SUBJECT: Safety Recall 05S28-S7
Certain 1994-1996 Model Year Bronco, 1994-2002 F-150/250 (Under 8500 GVW), 1997-2002 Expedition, 1998-2002 Navigator, and 2002 Blackwood Vehicles Equipped With Speed Control
Speed Control System Modification

REASON FOR UPDATE

The purpose of this supplement is to announce that seed stocking of the new service part (Fused Jumper Harness) will begin the week of November 28, 2005, and to announce new repair procedures and labor operations for the repair of all affected vehicles. (See Attachment II for details.)

FIGURE 1

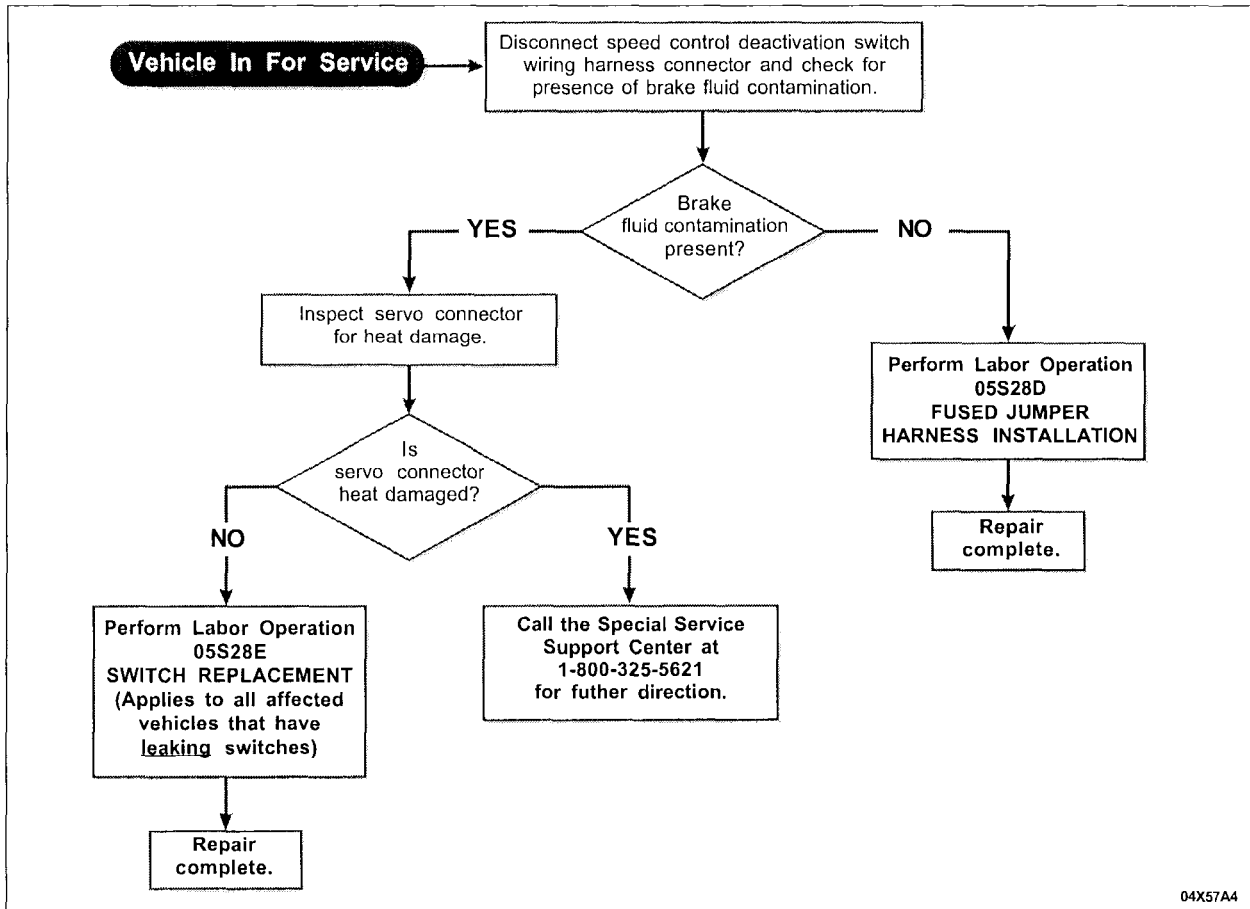
This program involves performing an inspection procedure to determine which repairs to the speed control system must be performed; either installation of a fused jumper harness or replacement of the speed control deactivation switch. A flow chart has been developed to direct you to the proper service actions. See Figure 1.

FIGURE 2

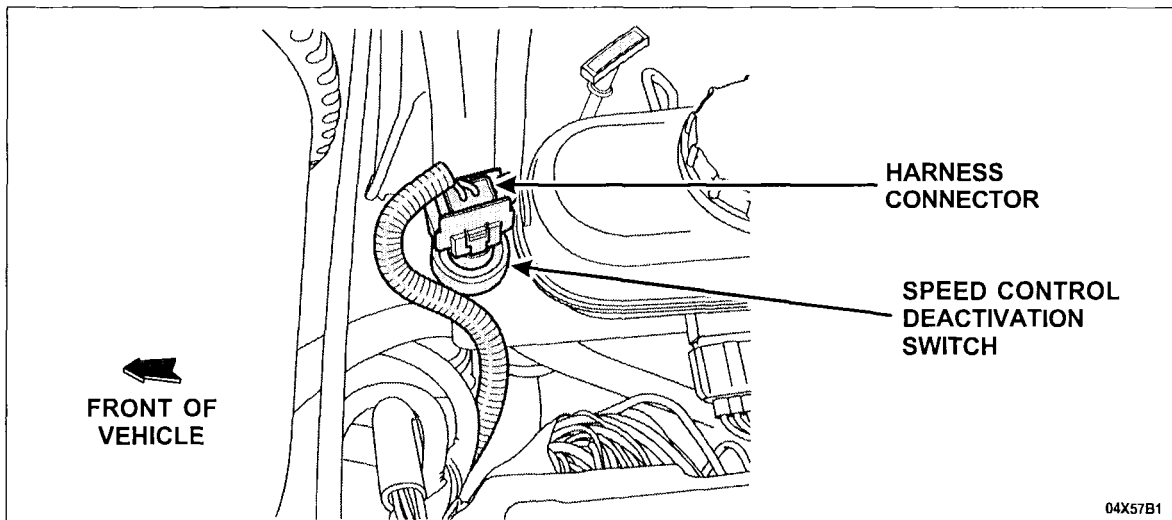
1. Disconnect the speed control deactivation switch located on the brake master cylinder and inspect the harness connector for the presence of brake fluid. See Figure 2.
 - If no brake fluid is present:
 - install the fused jumper harness (Labor Operation D).
 - If brake fluid is present, disconnect the speed control servo and inspect the vehicle harness connector for heat damage. See Figure 3.
 - If no heat damage is found at the speed control servo connector (even if there is presence of brake fluid in the connector), proceed to Labor Operation E.
 - If the speed control servo connector is heat damaged, call the Special Service Support Center at 1-800-325-5621 for further instructions.

FIGURE 4

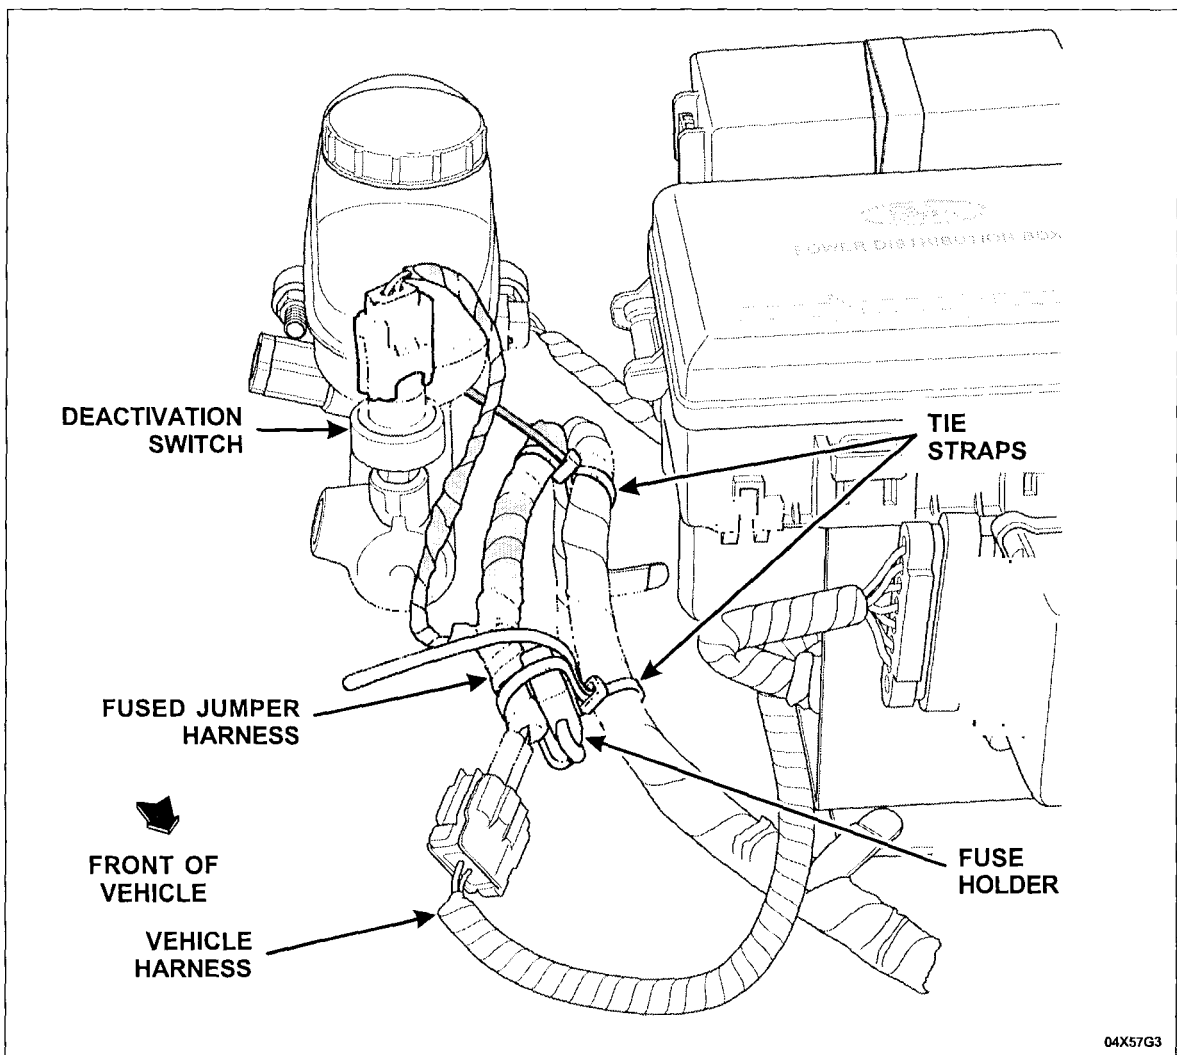
1.
 - a) Connect the fused jumper harness (14A411) to the speed control deactivation switch and the vehicle harness.
 - b) Position the harness alongside the existing harness, located below the master cylinder, so that the fuse holder is higher than the rest of the jumper harness. This will cause any water that enters the engine compartment and gets on the jumper harness to run downhill away from the fuse holder.
 - c) Secure the jumper to the existing harness with tie straps, making sure the fuse holder is positioned vertically with the cap facing upwards. Wrap the tie straps underneath, then over the top of the existing harness and verify proper fuse holder orientation. See Figure 4.
2. Release the vehicle.

FIGURE 5

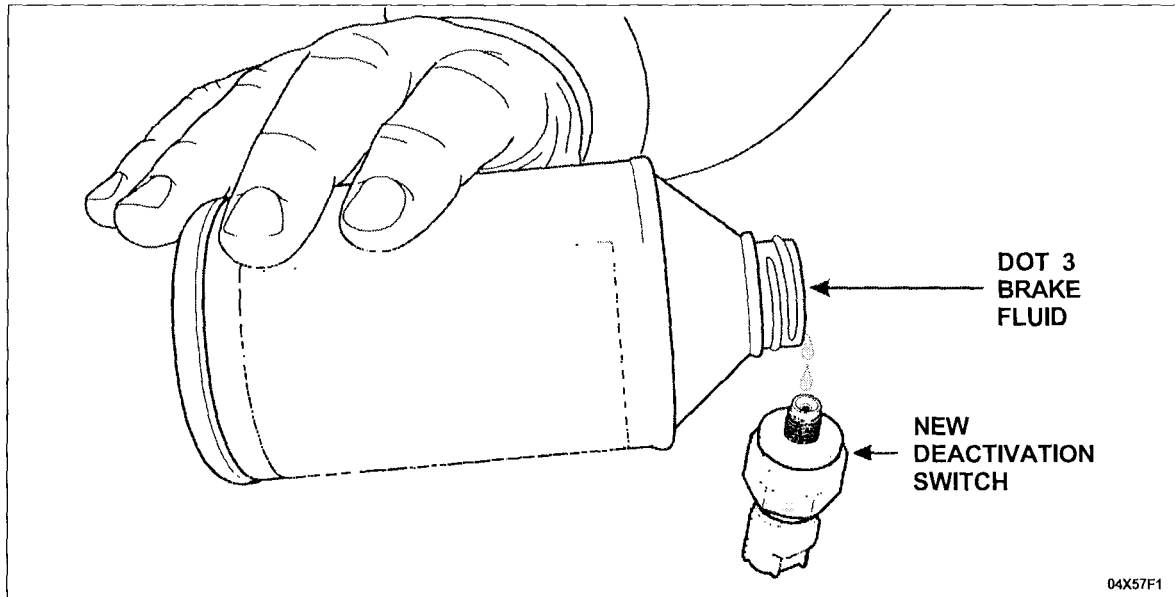
Add a few drops of Motorcraft High Performance DOT 3 Brake Fluid, PM-1, to the fluid port at the threaded end of the **new** deactivation switch. See Figure 5.
